AMENDMENT 005

ADDENDUM #1

Project title/Titre du projet
**AGASSIZ, BC
KENT MAXIMUM SECURITY
INSTITUTION**

**MECHANICAL SYSTEM
UPGRADE FOR CELL BLOCKS
A through H and J & K**

Sheet/Feuille

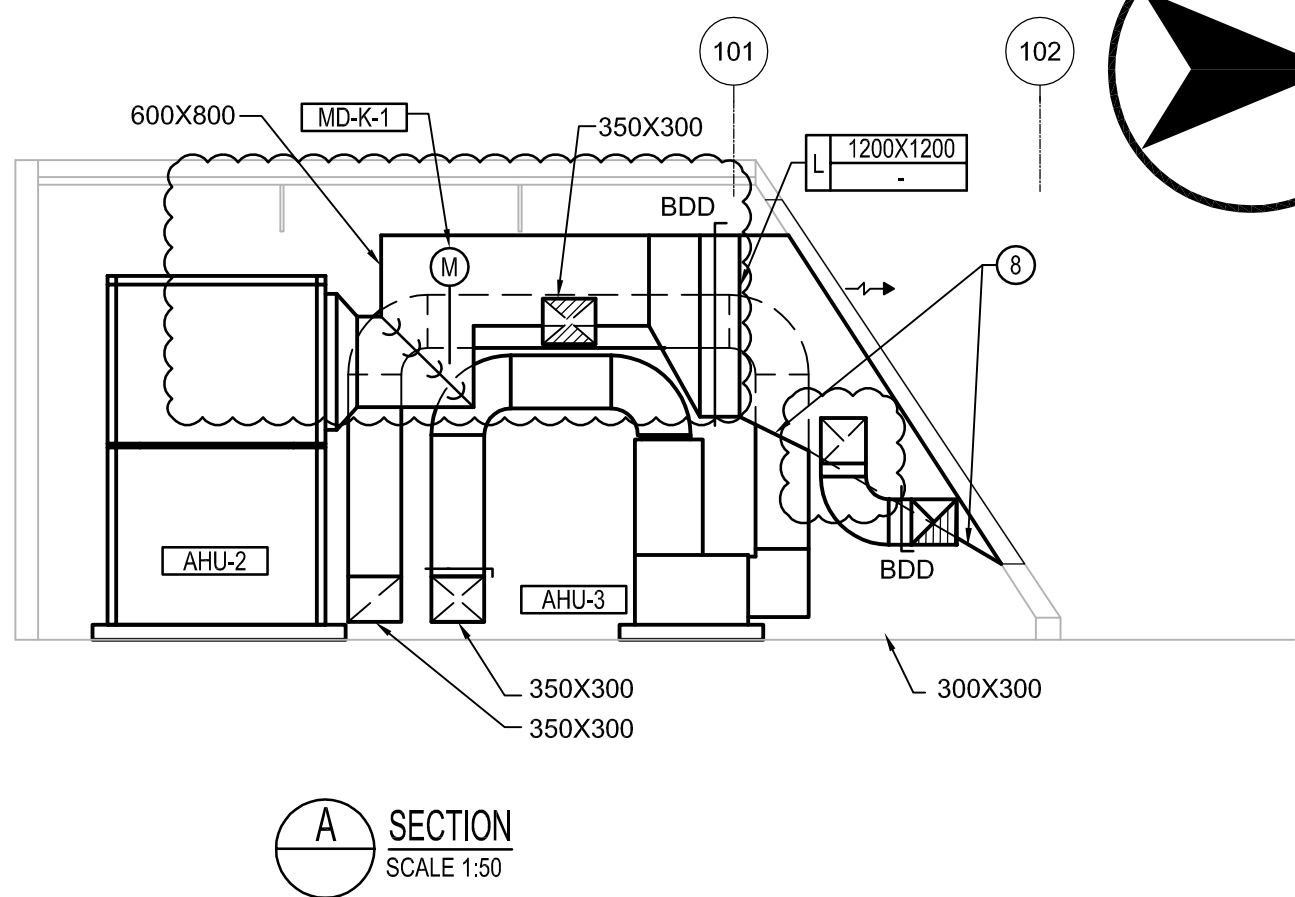
1. Refer to Tender Mechanical Drawings M4-01:

1. Revise mechanical equipment room (J&K) HVAC system as shown clouded on the details No. 2, A, B, C and D of the attached drawing

- (2) Provide new refrigeration piping complete with insulation.
 - (3) Run new refrigerant piping up to mechanical rooms J and K, and from mechanical rooms to the roof as shown on the detail No. 1 on the attached drawing M4-01. Allow for approximately a total of 150 meter for each refrigerant Liquid Line and Suction Line.

M5-01

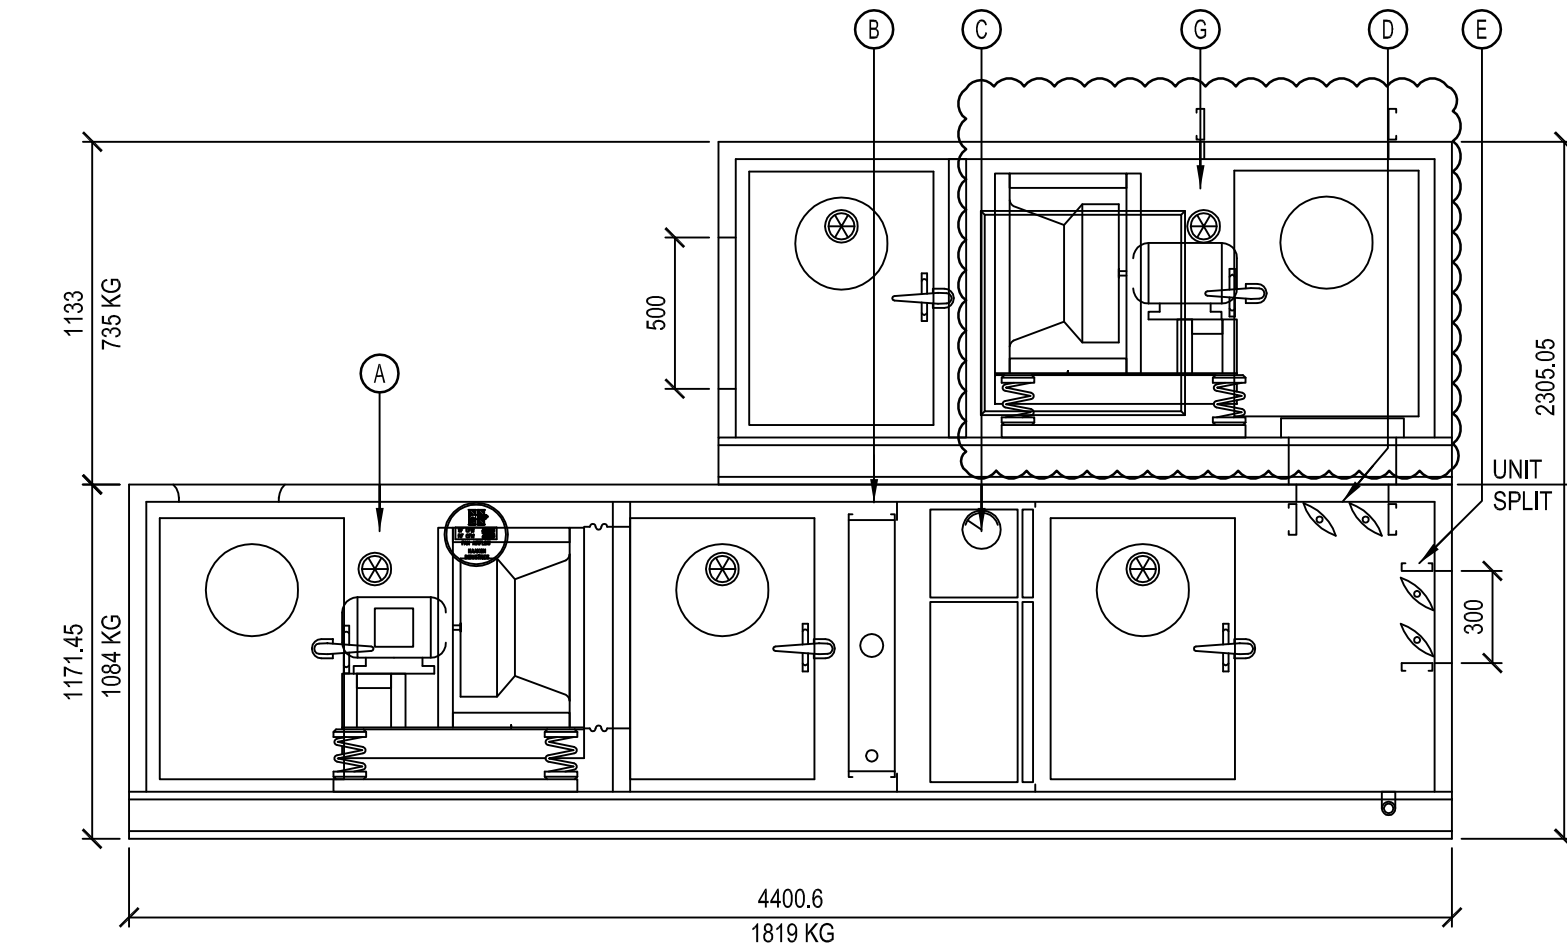
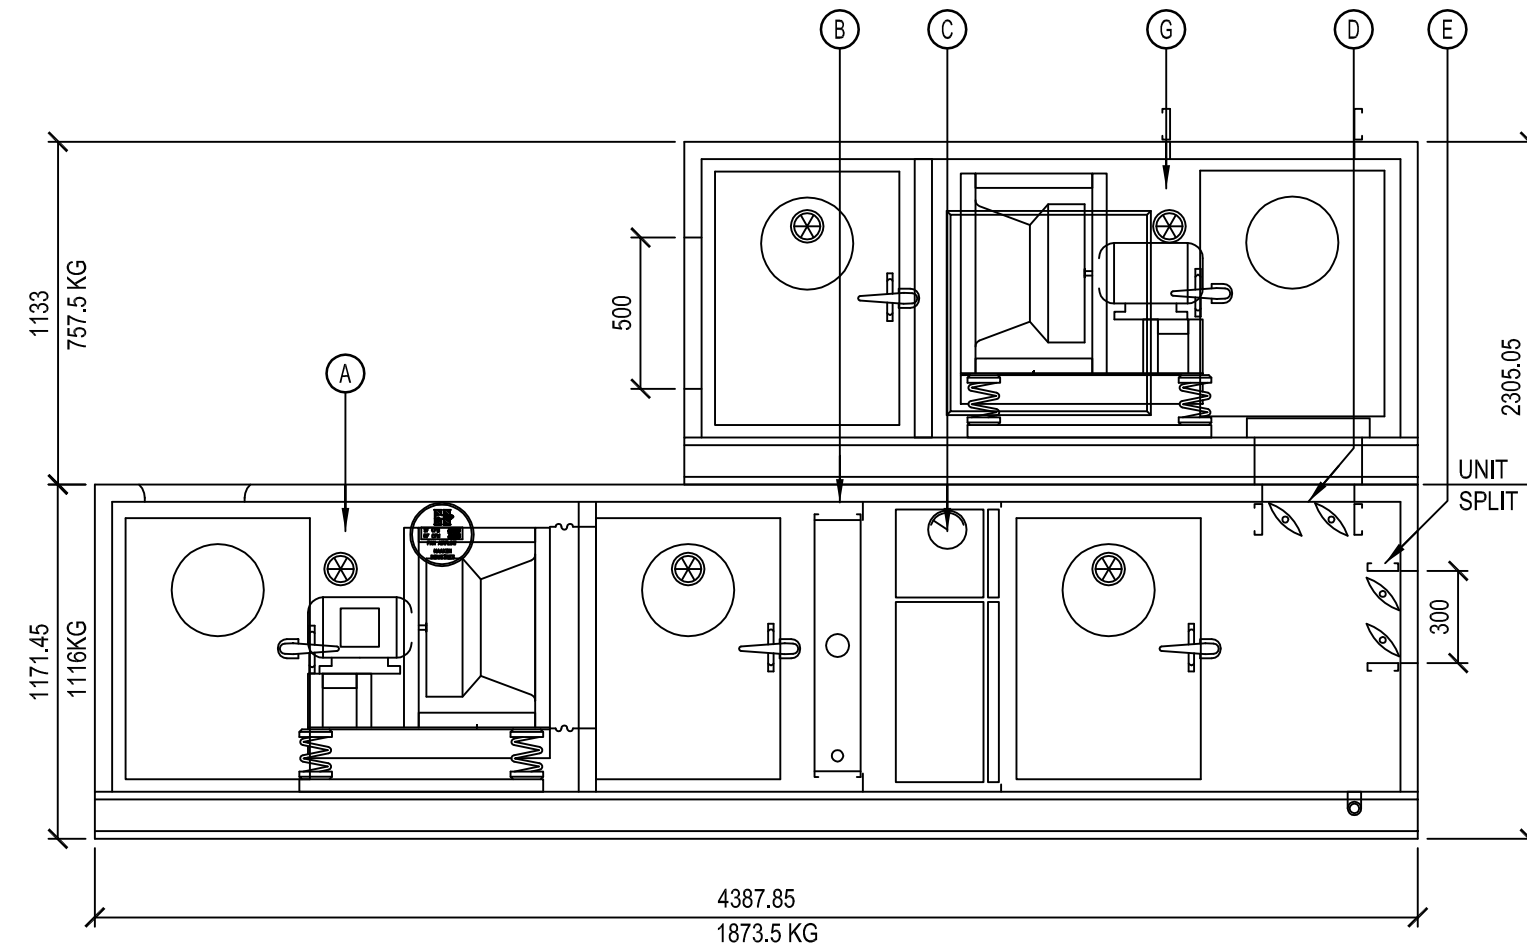
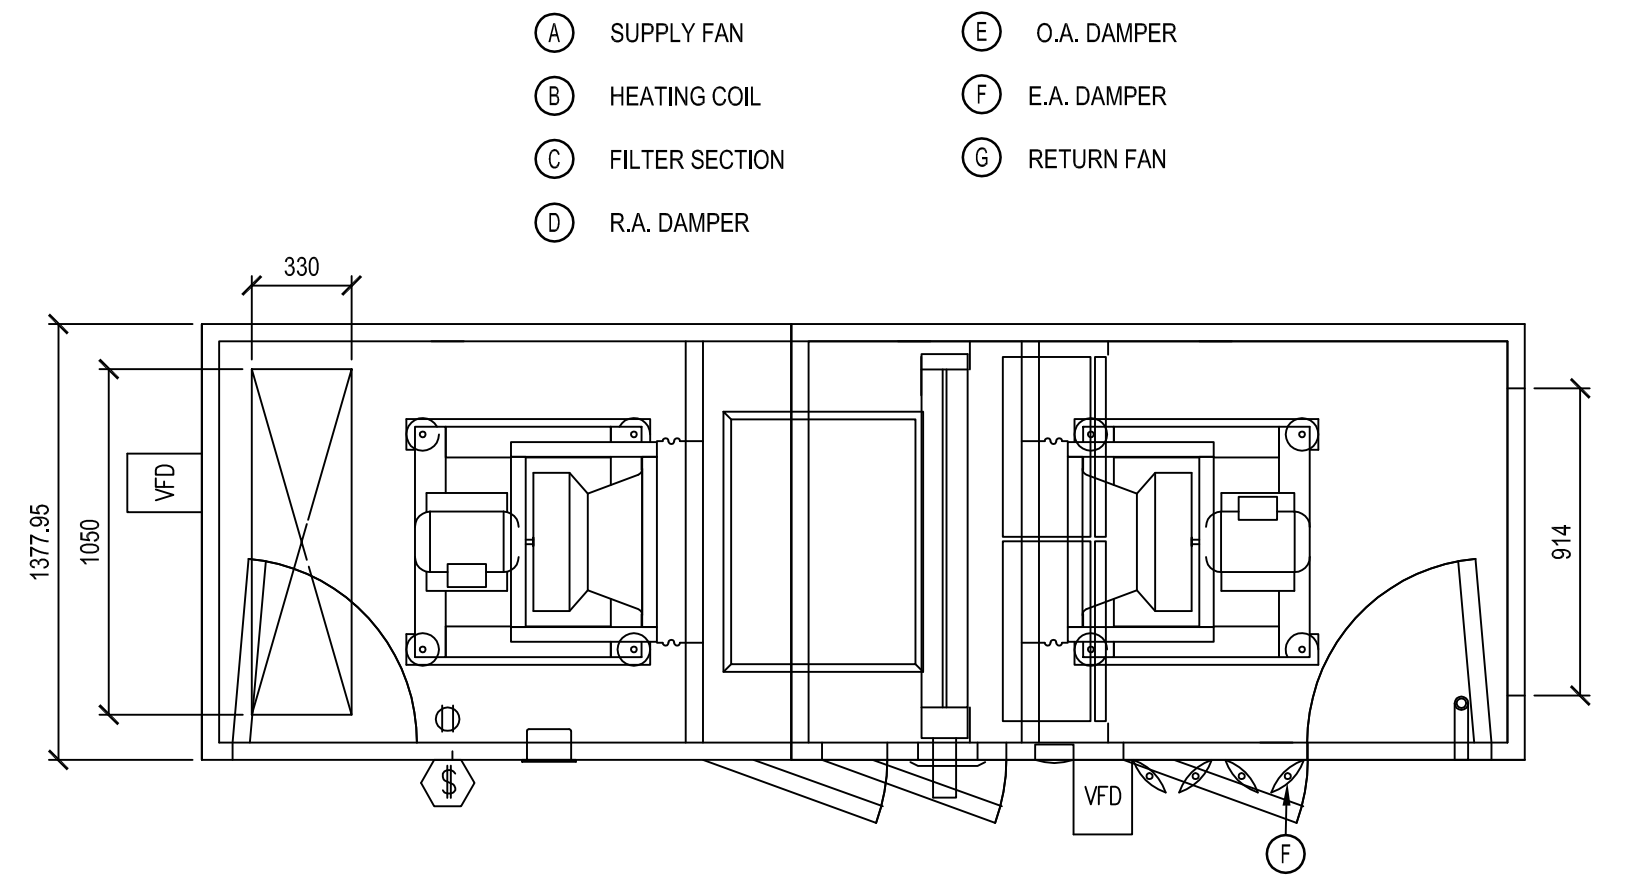
2. Refer to Tender Mechanical Drawings M5-01:

1. Revise mechanical details for AHU-1(Living Unit J) as shown clouded on the attached drawing.
2. Add mechanical details for AHU-2 (Living unit K) as shown clouded on the attached drawing.

E RETURN SYSTEM IN SERVICE CHASE (RENO)
1:20

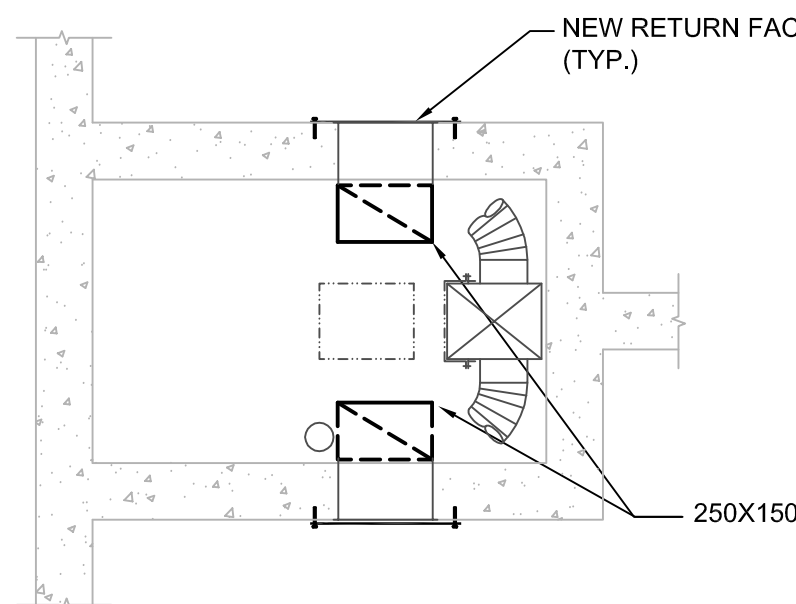
7. Refer to Tender Mechanical Drawings M9-03:

1. Add detail "E" for return air grilles at upper levels of Living Units A to H as shown clouded on the attached drawing.
